AUGMENTED INSPECTION TEAM (AIT) INSPECTION

Report Nos.: 50-261/93-34

Facility Name: H. B. ROBINSON UNIT 2

FIGURE Y - GADOLINIUM FUEL ASSEMBLY AS DESIGNED VS AS-BUILT

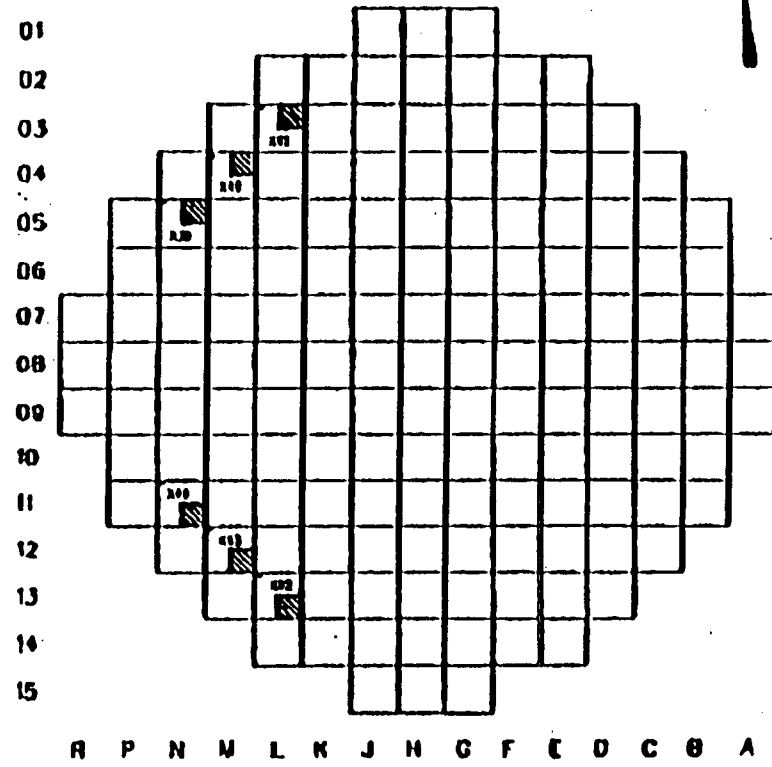
On November 18, 1993, during cycle-16 plant start-up, it was determined that a manufacturing error had occurred and six misconstructured fuel assemblies had been installed in the Robinson core. The fuel assemblies had been built 90 degrees out of the correct orientation because incorrect load map drawing information had been entered into the manufacturing computer system. Two subsequent Quality Control overchecks failed to detect the error.

The computer then provided a series of prompts to allow the clerk to enter the location of the fuel rods within the fuel assembly. The documents used to load in the fuel assembly information included the parts list (a reviewed and approved design document), the load map drawing (a reviewed and approved design document), and the insertion sequence (an informal document which indicated the order in which the assembly table placed fuel rods into the fuel assembly, a manufacturing document). The clerk defined a set of "find numbers" used to identify rod types and then entered the insertion sequence using the find numbers. This information was obtained from the load maps and insertion sequences which were incorrectly specified for fuel assembly numbers 140148 and 140150. As a result, the computer program was loaded with design information and manufacturing instructions which would place the fuel rods in incorrect positions when the fuel assemblies were manufactured.
